# UNITED STATES PATENT AND TRADEMARK OFFICE

APPLICATION NO.	FILING DATE	FIRST NAMED INVENTOR	ATTORNEY DOCKET NO.	CONFIRMATION NO.
10/769,920	02/03/2004	Shinji Hayashi	086142-0633	9767
22428	7590	03/23/2007	EXAMINER	
FOLEY AND LARDNER LLP SUITE 500 3000 K STREET NW WASHINGTON, DC 20007			SLITERIS, JOSELYNN Y	
			ART UNIT	PAPER NUMBER
			3616	
SHORTENED STATUTORY PERIOD OF RESPONSE		MAIL DATE	DELIVERY MODE	
3 MONTHS		03/23/2007	PAPER

## DETAILED ACTION

FIG. 4 A

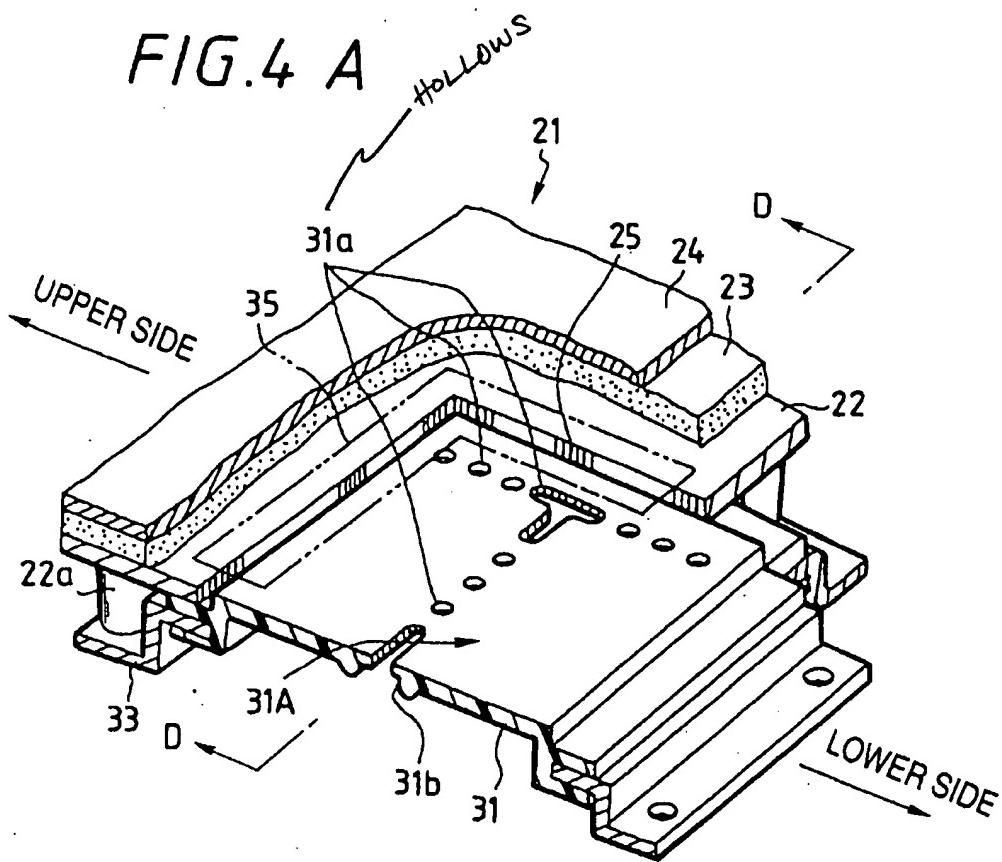
5. Regarding claims 29-32, 34-37, and 43, Uehara discloses a method of making a cover component 31A (Figs. 4A, 4B) mountable to an airbag system, as in the present invention, the cover component having a tear line 31a, 31b that is torn open when an airbag of the airbag system inflate, comprising:

wherein the tear line 31a, 31b extends in an H shape (Figs. 1A, 4A);

wherein the tear line extends in an H shape (Figs. 1A, 4A);

FIG. 4 B

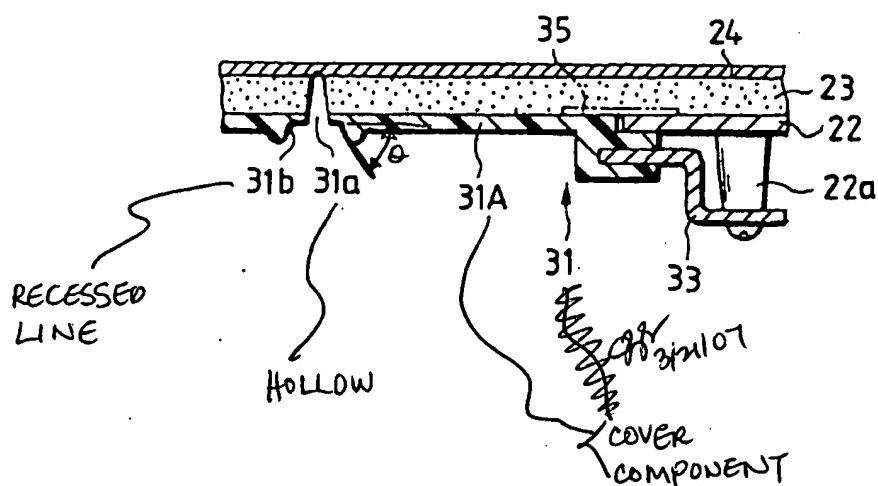
wherein a bottom recess of the recessed line near an end of the recessed line is molded to form a slope about 30° to 60° inclined relative to a back of the cover component (see annotated Fig. 4B attached);

further comprising forming a bottom recess of the recessed line near an end of the recessed line in a slope about 30° to 60° inclined relative to a back of the cover component (see annotated Fig. 4B attached).

13. Applicant further argues on pages 5-6 of the Remarks, "For example, ... First, the line drawn by the Examiner in the Office Action is not accurate. Figure 4(b) of Uehara appears to have a vertical line along the side of the groove 31b. See Uehara at Fig. 4(b). Second, the angle drawn by the Examiner is based off of a side of the groove 31b, and not "near an end" as required by claim 32."

First, examiner is unclear about the vertical line along the side of the grove 31b

referred by applicant. Second, examiner notes that the angle drawn by the examiner based off of a side of the groove 31b is applicable "near an end" of the recessed line, as broadly recited. Therefore, examiner maintains that the rejection is proper.

FIG.2

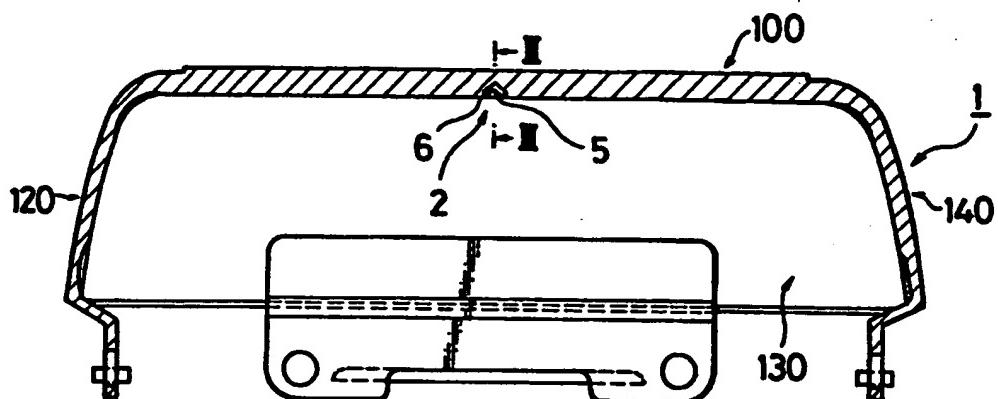
a plurality of hollows 6 in said recessed line in said molded material at intervals (Figs. 2, 3);

wherein the cover component 100 comprises only a single layer (Figs. 2, 3);

hollows 6 in the recessed line at intervals (Figs. 2, 3);

FIG.4

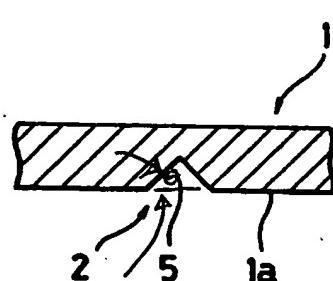
wherein a bottom recess of the recessed line near an end of the recessed line is molded to form a slope about 30° to 60° inclined relative to a back of the cover component (see annotated Fig. 4 attached);

wherein the recessed line decreases in depth gradually toward an endmost of the tear line (Fig. 4);

further comprising forming a bottom recess of the recessed line near an end of the recessed line in a slope about 30° to 60° inclined relative to a back of the cover component (see annotated Fig. 4 attached);
